# Team Update 01

# Team Update 02

# Team Update 03

# Team Update 04

Figure 0-1 TRENCH bottom view

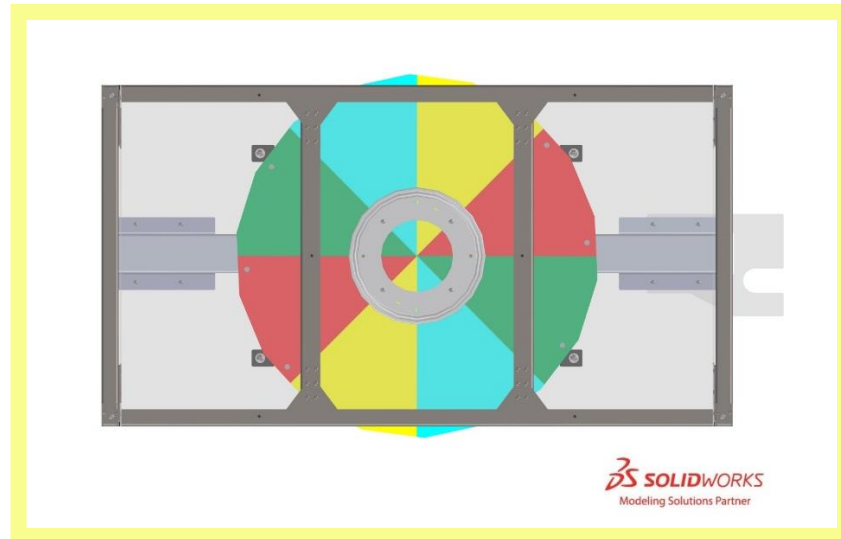
- FIRST Official CAD Models, updated at 5pm on 1/2/2020
    - Updated location of TRENCH
  - Layout and Marking Diagram, updated at 5pm on 1/2/2020
    - Updated location and dimensions associated with TRENCH

Figure 0-2 POWER PORT Vision Target

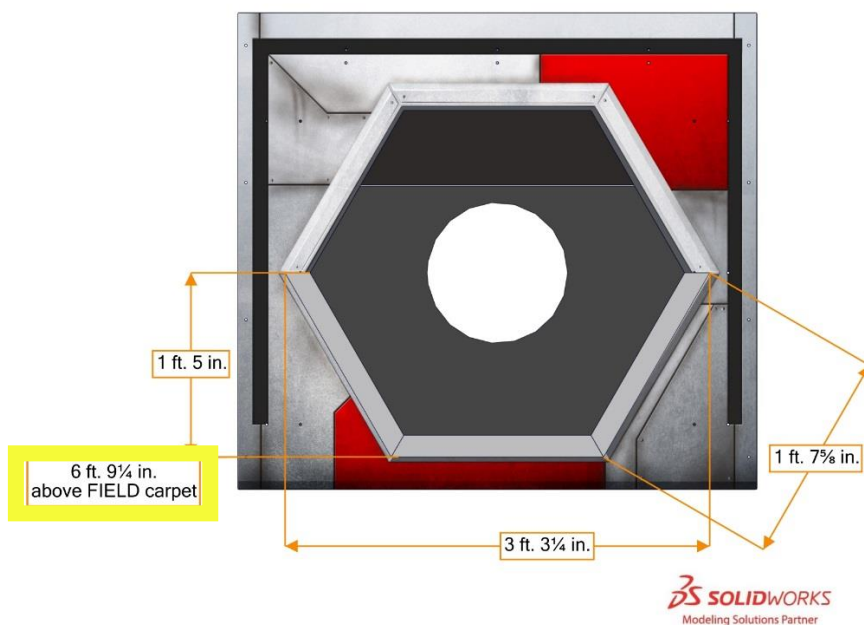
Vision targets made from 2 in. (~5 cm) wide strips of 3M 8830 Scotchlite™ Reflective Material are located on the POWER PORTS and LOADING BAYS. On the POWER PORT, they target the location of the INNER and OUTER PORTS and trace the bottom perimeter of the OUTER PORT. The target has an overall height of 1 ft. 5 in. (~43 cm), and a width of 3 ft. 3¼ in. (~100 cm). The bottom of the target is 6 ft. 9¼ in. (~206 cm) above the carpet. A strip of 3M 8830 Scotchlite™ Reflective Material is in each Black Tote of the [2020 Kickoff Kit](#) **FIRST Choice**.

Figure 7-4 Examples of G18 compliance and non-compliance

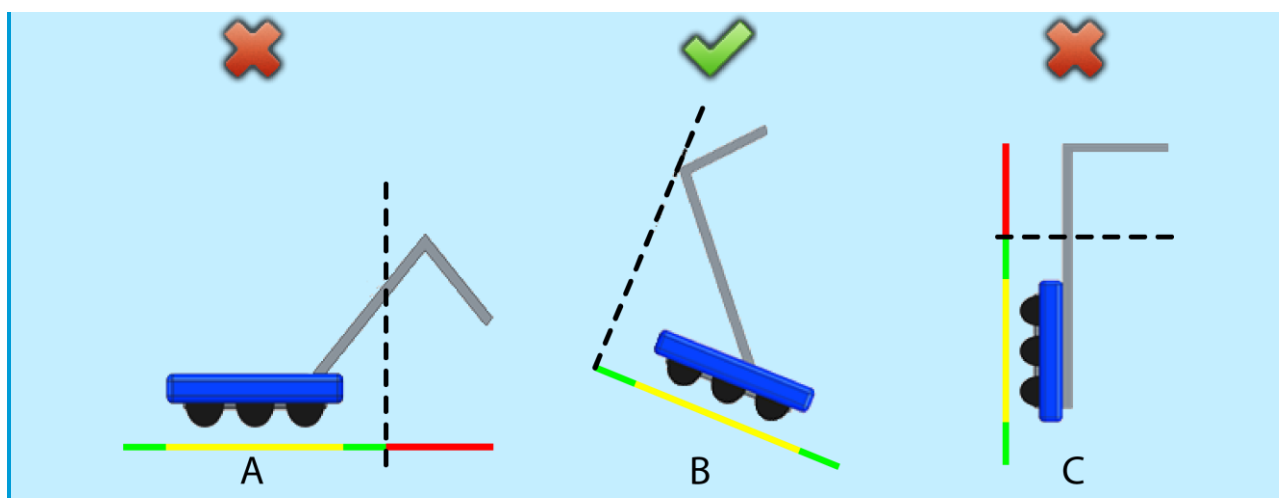
**G18. Don't overextend yourself.** ROBOTS may not extend more than 12 inches (~30 cm) beyond their FRAME PERIMETER.

Examples of compliance and non-compliance of G18 are shown in Figure 7-4.

Yellow bars represent the limits of the FRAME PERIMETER and are drawn in the same orientation of the ROBOT'S FRAME PERIMETER. Green bars represent a measured extension from the FRAME PERIMETER that does not violate G18. Red bars represent a measured extension from the FRAME PERIMETER that exceeds the limit in G18). ROBOTS A and C violate G18, whereas ROBOT B does not.

Figure 0-1 POWER CELL movement limitations

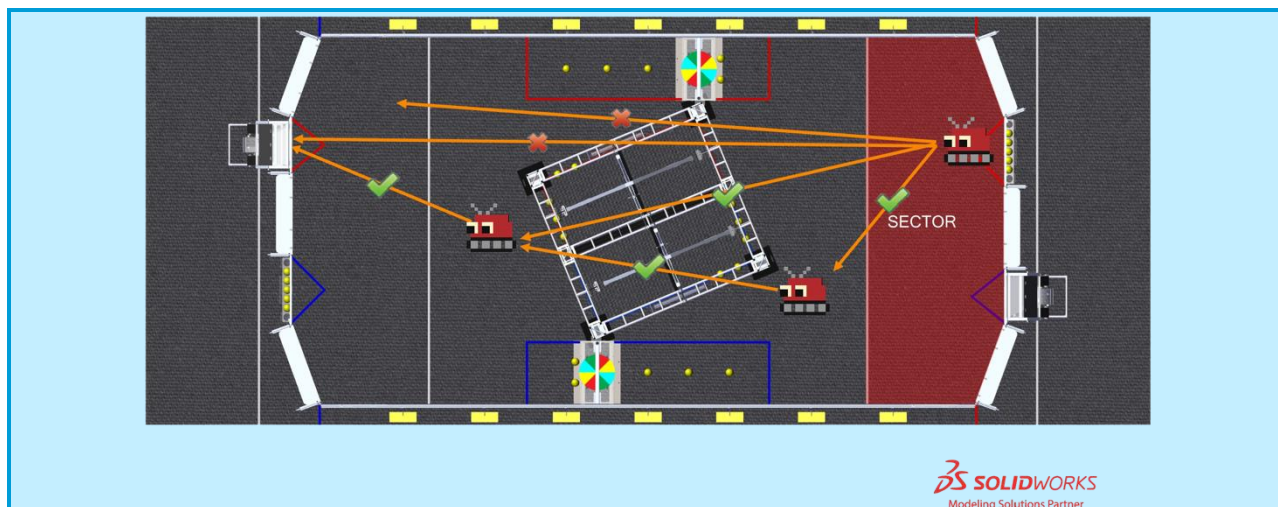
**G9. No full court shots.** A ROBOT whose BUMPERS are fully contained by their SECTOR may not cause POWER CELLS to travel into or through their opponent's SECTOR.

For the purposes of G9, “travel” means “to cause movement through the air, bounce across the floor, or roll without contacting an opponent ROBOT.” A POWER CELL is no longer “travelling” once it stops, or contacts an opponent ROBOT or is CONTROLLED by a ROBOT on their ALLIANCE. The cause of (i.e. responsibility for) a POWER CELL “travelling” may transfer from ROBOT to ROBOT as assessed by the REFEREE.
